**RE: Volcano Mesa at The Trails  
Grading Plan & Drainage Report  
Engineer's Stamp Date: 11/16/21  
Hydrology File: C18D088**

Based upon the information provided in your submittal received 12/02/2021, the Grading Plan & Drainage Report **are not** approved for Work Order and Grading Permit. The following comments need to be addressed for approval of the above referenced project:

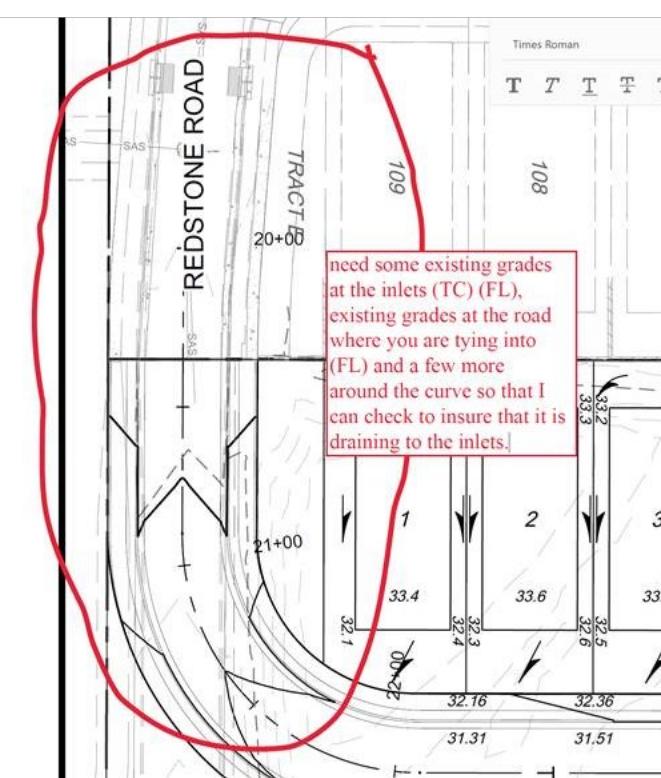
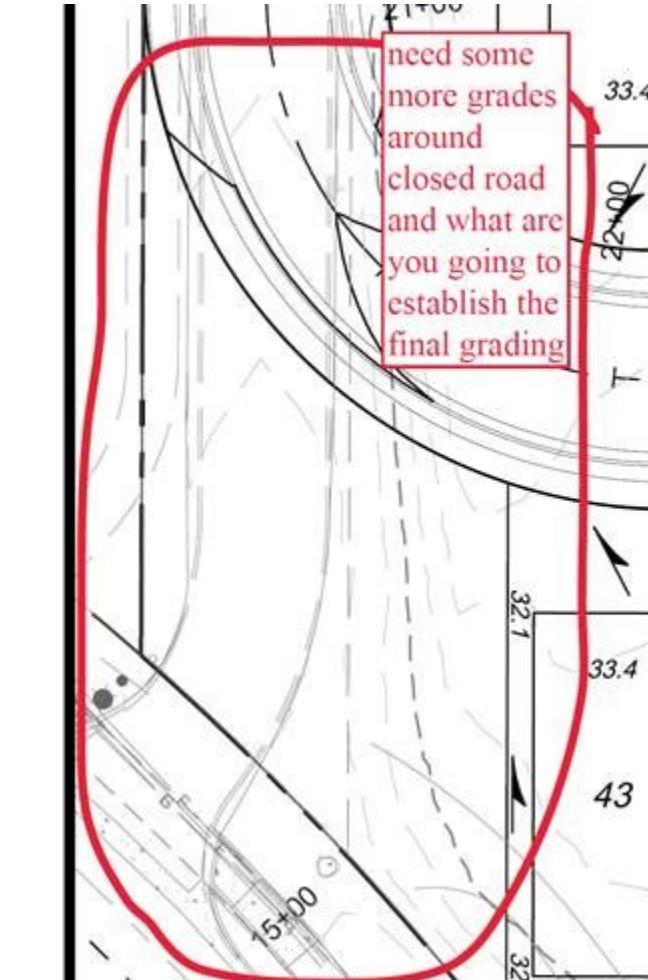
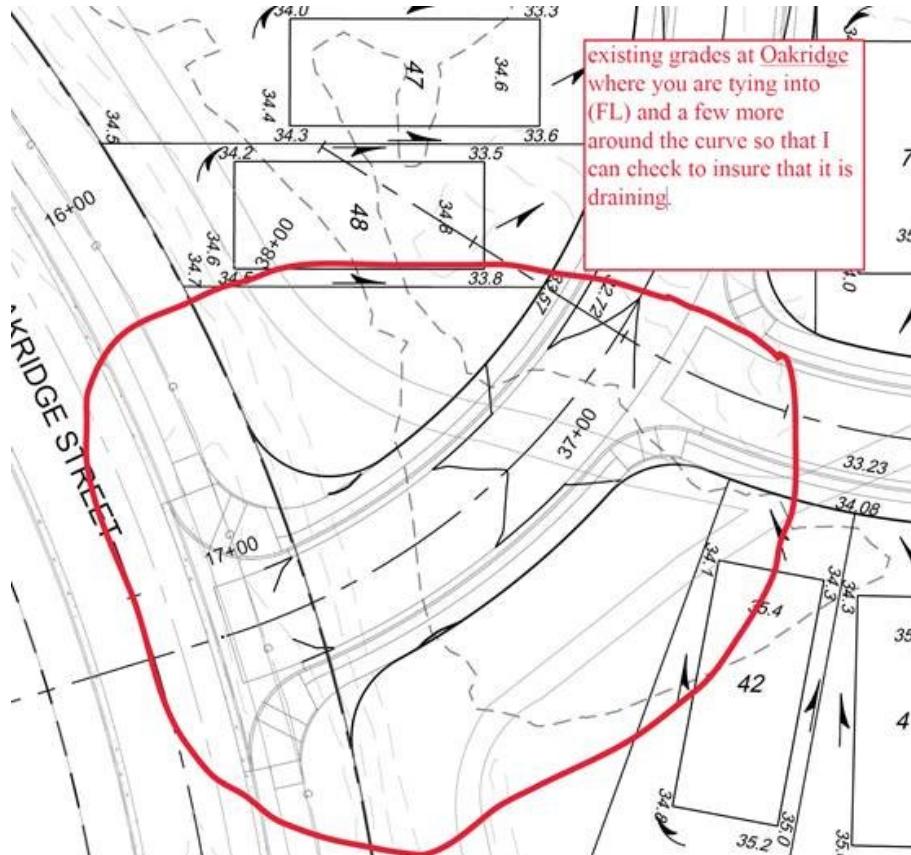
1. Please show additional grades as shown.

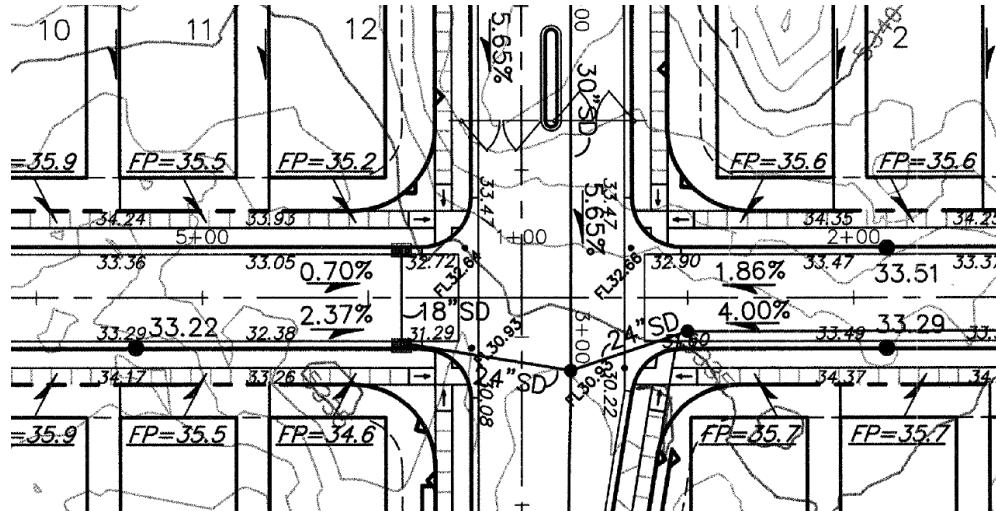
2. Also, please add the proposed inlets and storm sewer. Please provide just the flowline at the inlets and the pipe size. The actual build information will be in the Work Order construction set. Please see example below.
